STATE OF HAWAII DEPARTMENT OF TRANSPORTATION HIGHWAYS DIVISION MECHANICALLY STABILIZED EARTH RETAINING WALL (MSERW) TYPICAL SECTION AND DETAILS KAHKILI HIGHWAY WIDENING Likelike Hwy. to Vicinity of Haiku Road F.A. PROJECT NO. NH-083-1(26) SCALE: AS NOTED DATE: APRIL 1994 SHEET No. W1 OF W21 SHEETS	
--	--

AS-BUILT ADD. 114

KAHEKILI HIGHWAY WIDENING
Likelike Hwy. to Vicinity of Haiku Road
F.A. PROJECT NO. NH-083-1(26)

TYPICAL RETAINING WALL SECTION "B"
WALL NOS. 1B, 3A, 5, 8, 12, 14 & 18
 SCALE: 3/4"= 1'-0"

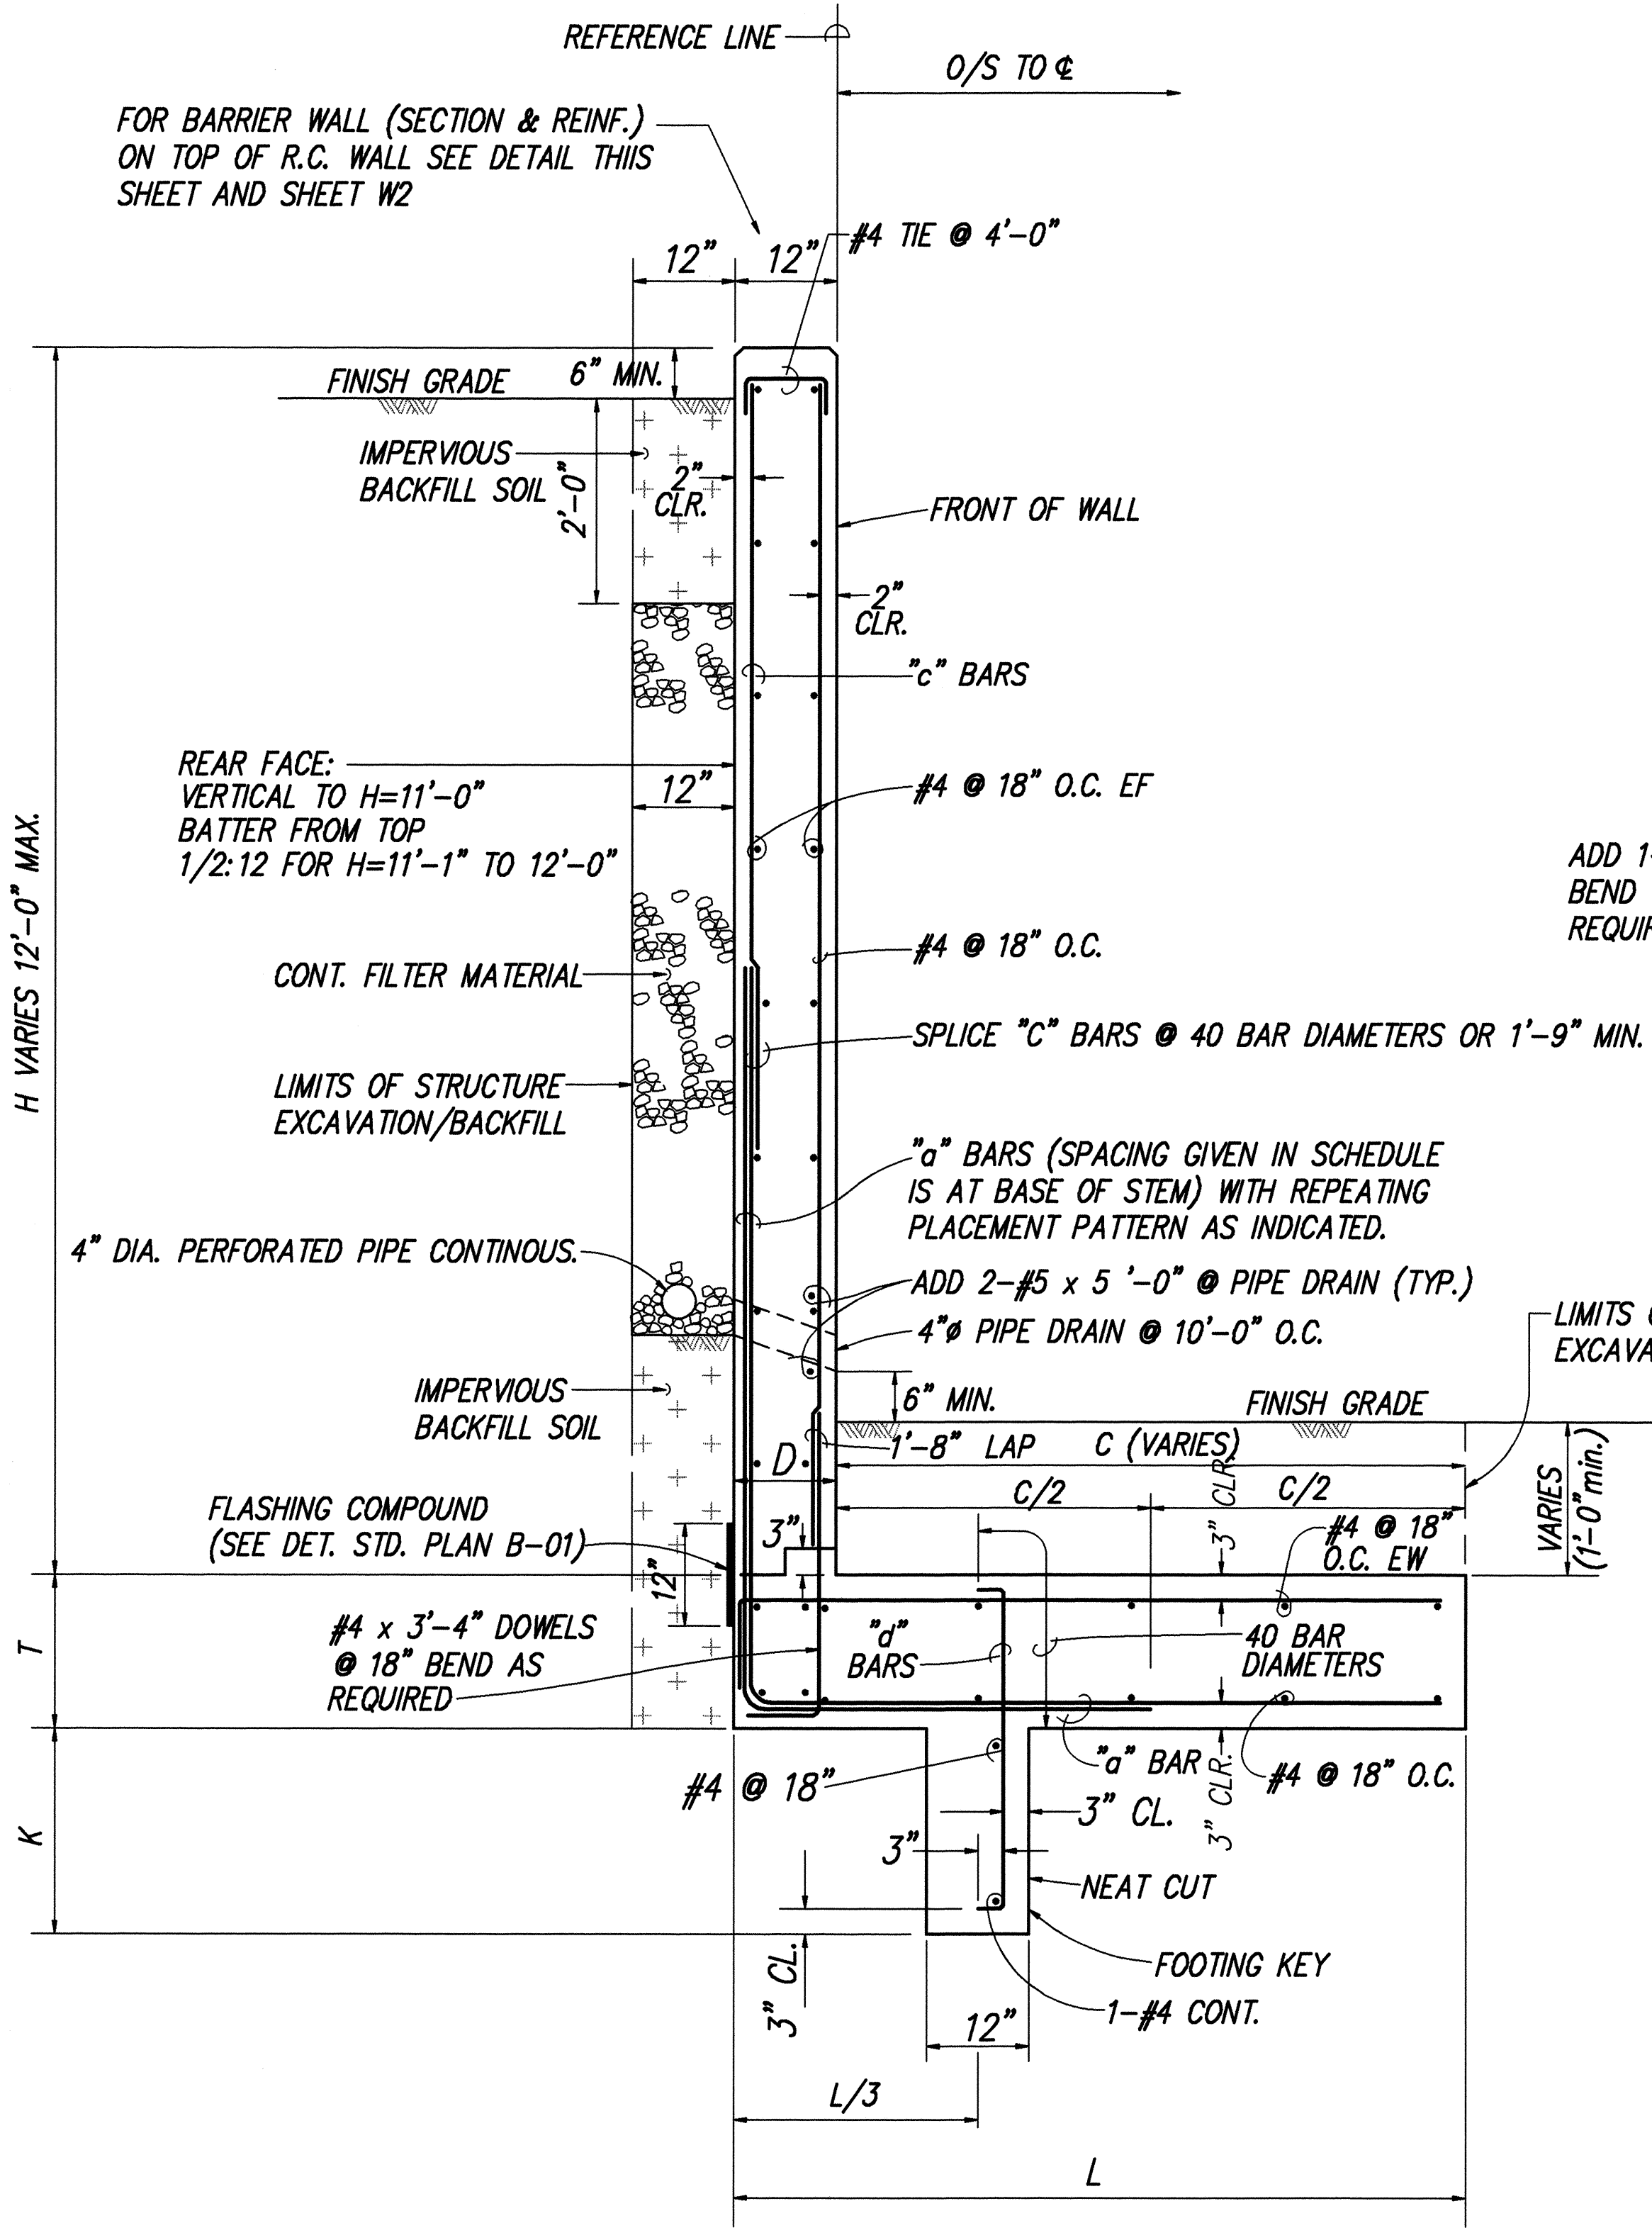
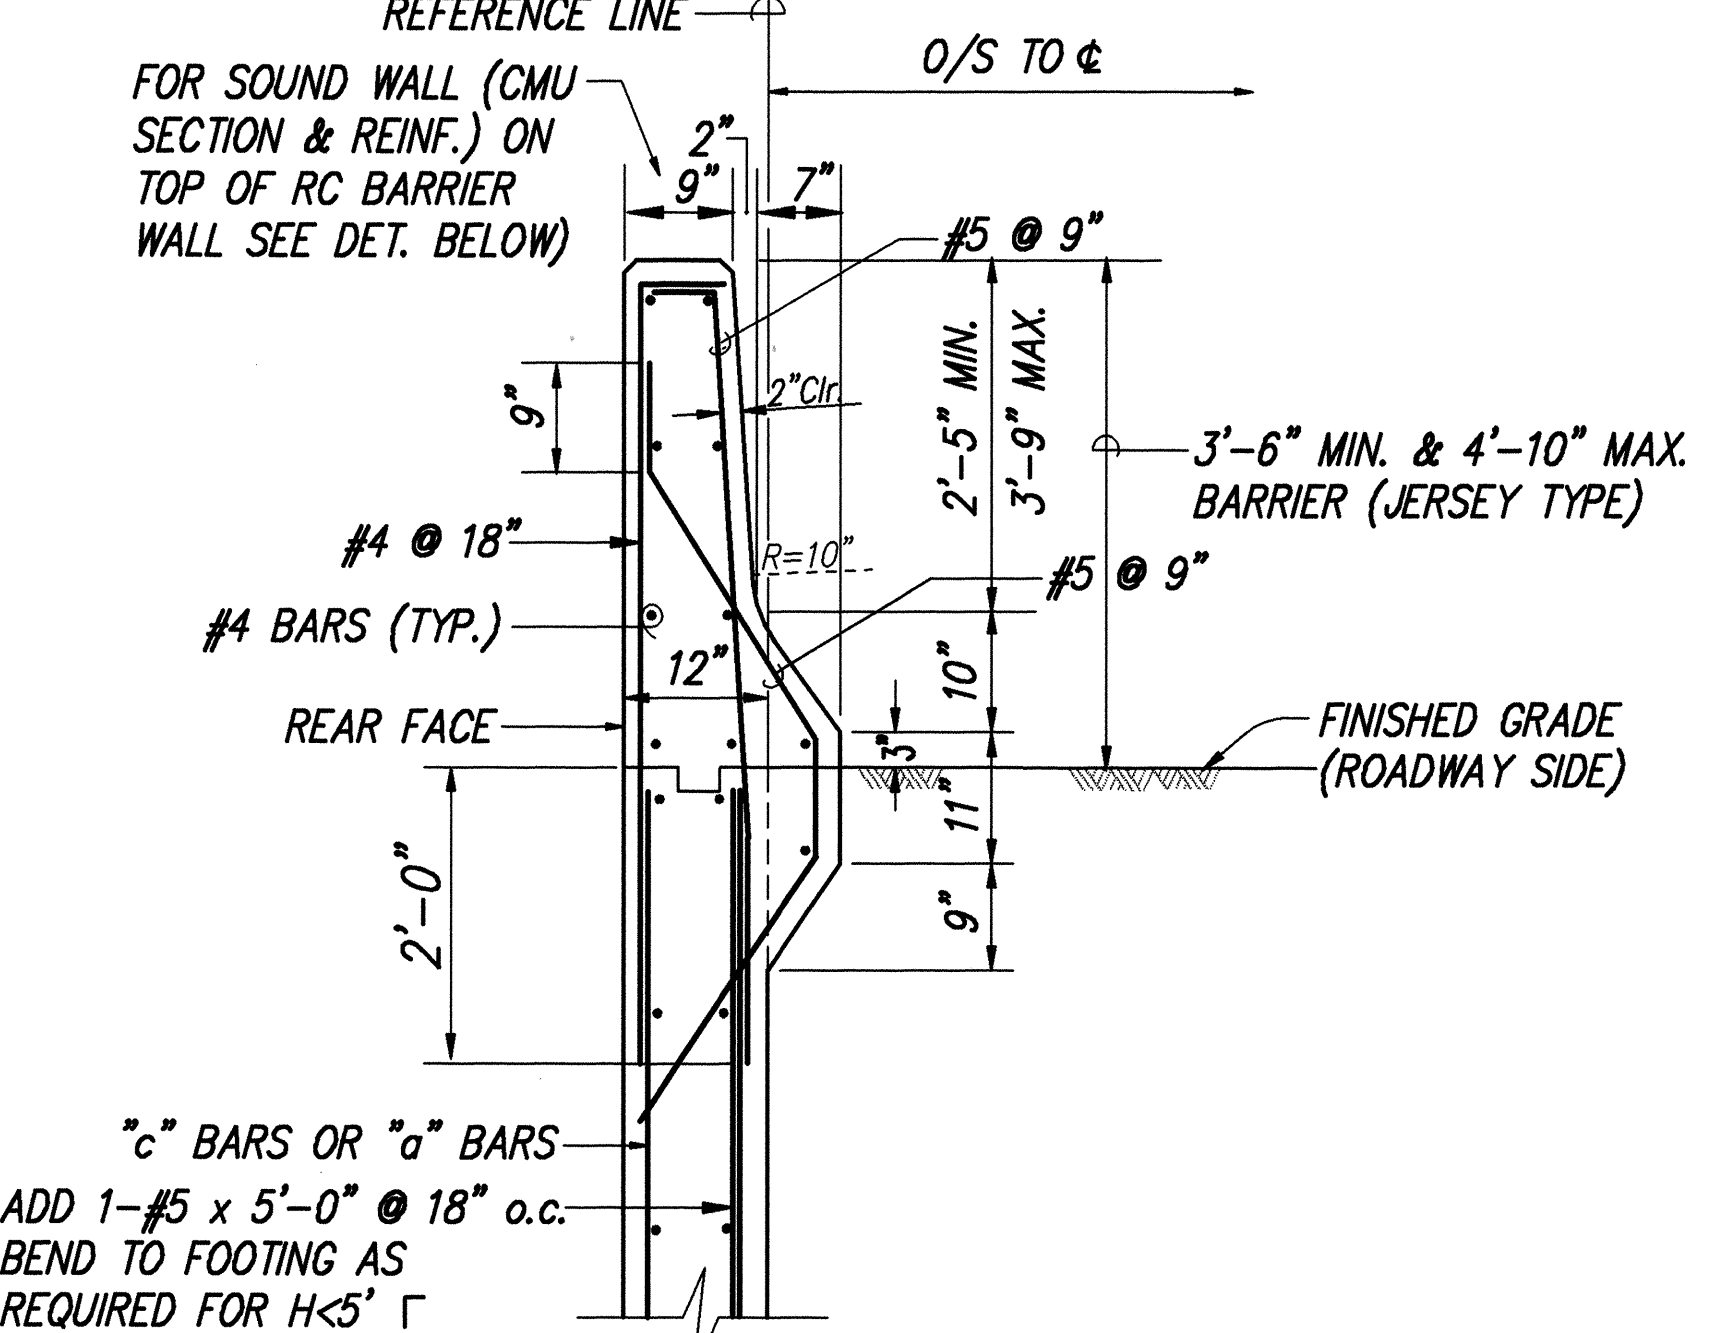
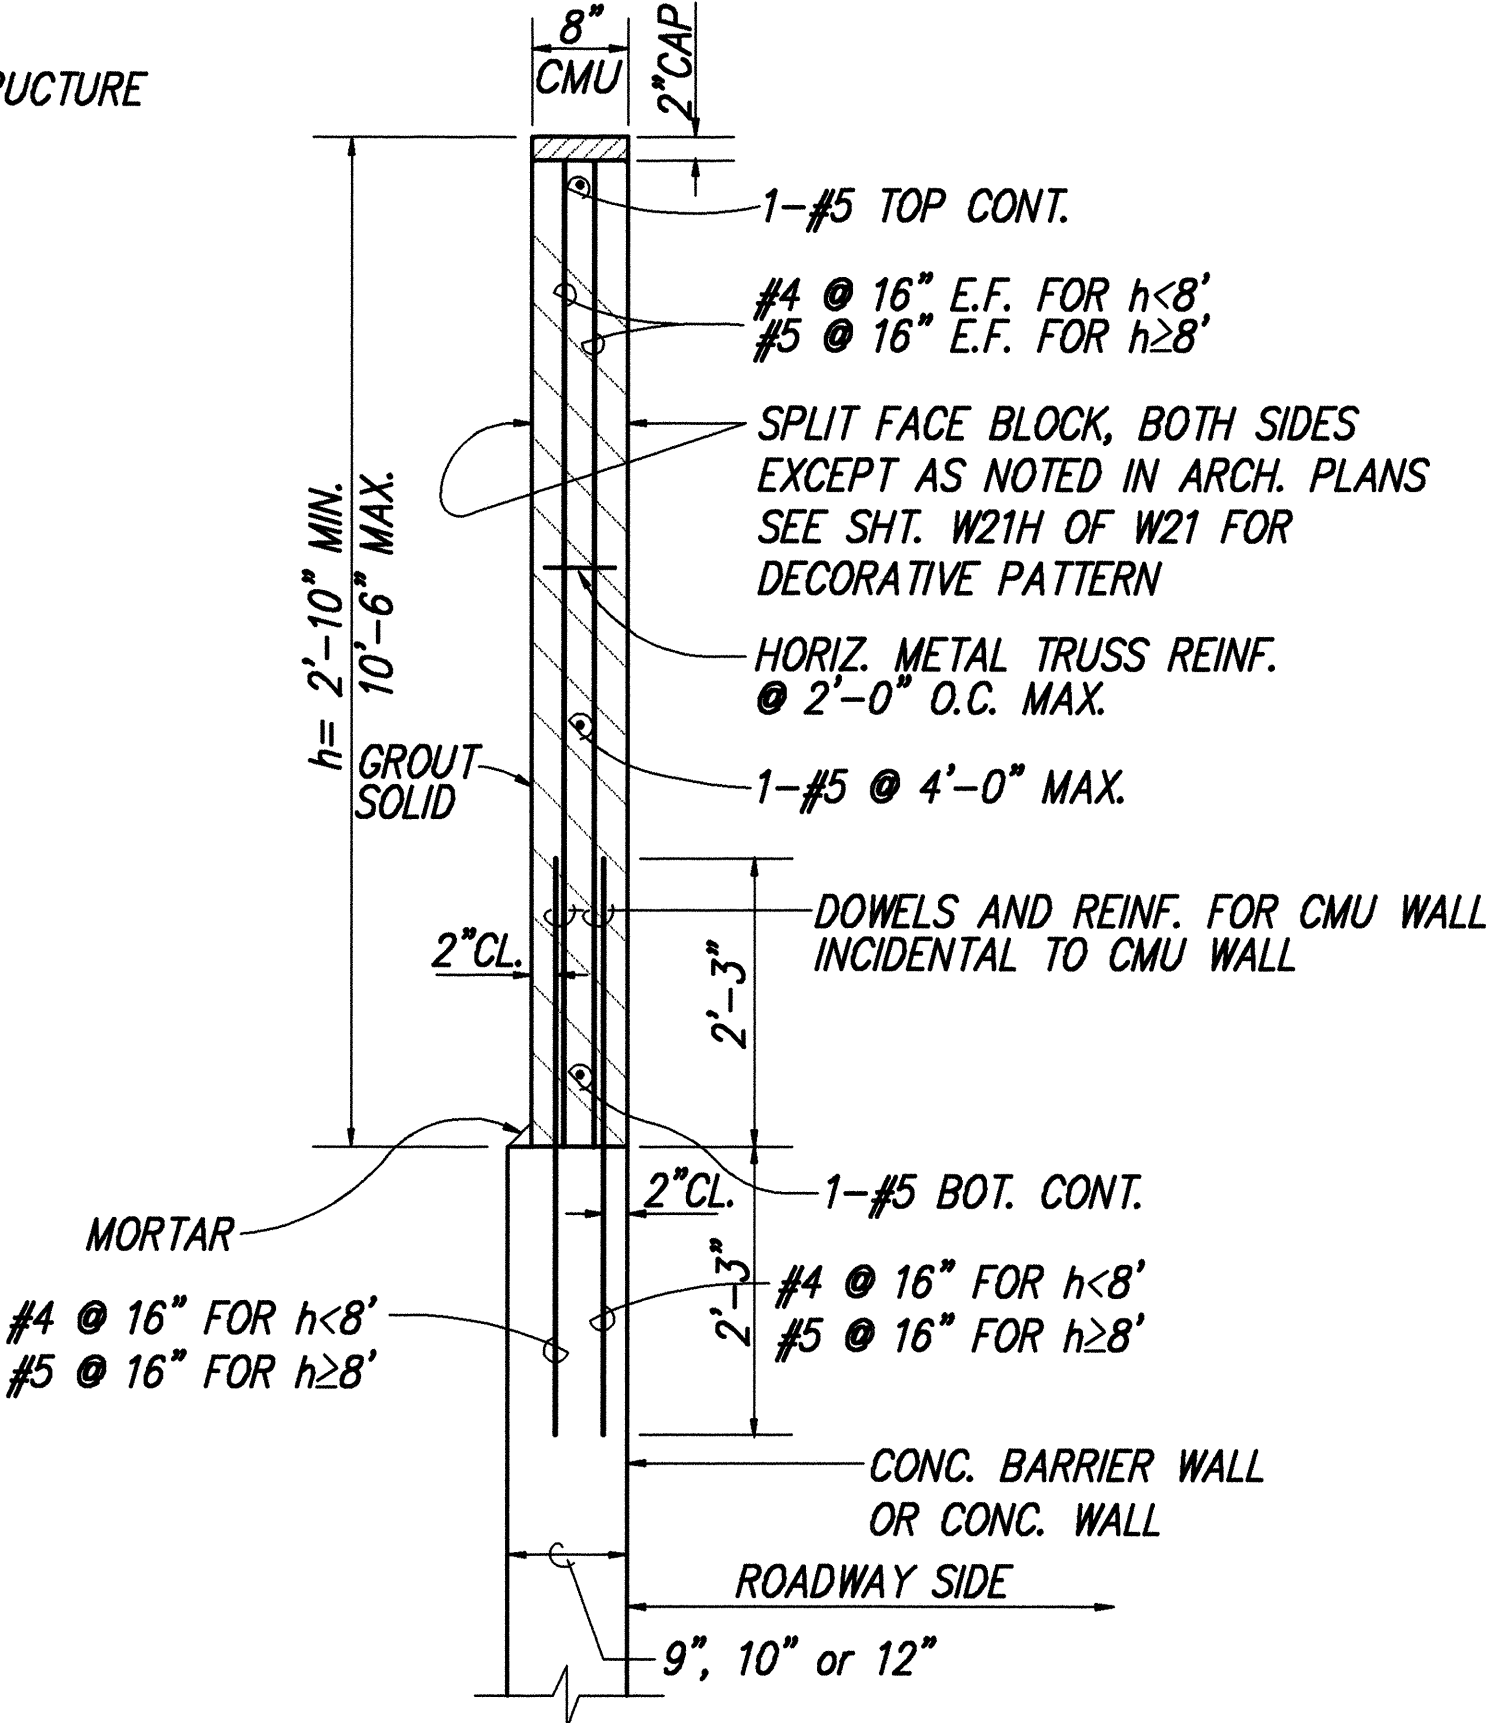
4/29/97	ADDED WALL NO. 19 TO SCHEDULE.
10/10/96	ADDED WALL NO. 18 TO SECTION B AND SCHEDULE.
6/07/94	REVISED BARRIER WALL AND SOUND WALL DETAILS. ADDED SCHEDULE FOR CONC. & REINF. STEEL FOR R.C. RETAINING WALLS AND BARRIERS & ADD LIMITS FOR STRUCTURE EXCAVATION/BACKFILL.
